PLANNING DIVISION STAFF REPORT

March 3, 2025

Project Address: 3915 Lien Road (District 3 – Alder Field)
Application Type: Conditional Use
Legistar File ID # [86523](#)
Prepared By: Chris Wells, Planning Division
Report includes comments from other City agencies, as noted.
Reviewed By: Kevin Firchow, AICP, Principal Planner

Requested Action: Consideration of a conditional use in the Commercial Corridor-Transitional (CC-T) District and Transit-Oriented Development (TOD) Overlay District for a drive-through window to allow construction a coffee shop with drive-through window at 3915 Lien Road.

Image 1: Access to the subject site (outlined in bold) and proposed access to the car wash (approved but not yet under construction) to the west. The new drive aisle accessing these two parcels is indicated with the dashed red line.

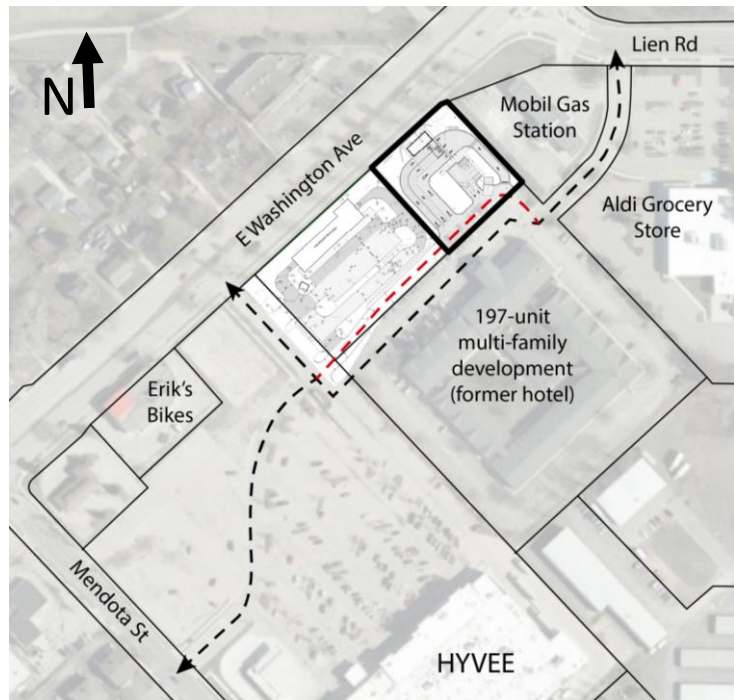
Once on the access aisle, automobiles will enter the subject site at the south corner and line up in one of two parallel queuing lanes which circulate clockwise around the site. The drive-through window is located on the southeast façade of the building, beneath the second-story portion of the building which extends over these drive aisles. As for the operations of the drive-through service, the applicant notes in submitted materials and communications with Staff that employees "greet customers at their cars with iPads to take their orders." Cars "usually don't form long queues outside because employees will walk down the line and take the orders with iPads [...] so they will not be ordering just when they arrive at the covered area of the building." In total, their aim is for the entire process, from order to pick up, to last at most four minutes. In the event a customer changes their mind, there is a third lane on the right/inside of the loop to bypass or exit the drive-through windows and loop around and exit the site where they first entered. The proposed hours of operation are Sunday-Thursday 5:30am - 10pm; and Friday-Saturday 5:30am - 11pm.

In the middle of the site, in the island created by the drive-through lanes, are four surface automobile parking stalls and the trash enclosure area. These will all be accessed from the main drive aisle which runs along the southeast property line. The applicant has noted that these four stalls are intended but not exclusively for employees (of which there are typically anticipated to be 5-8 on site at a given time); customers are welcome to park there if there are spots available. Furthermore, the applicant notes that the owner of the apartment complex to the south is agreeable to allowing the employees of the 7 Brew building to use the existing parking stalls located just off the subject site, to the southeast.
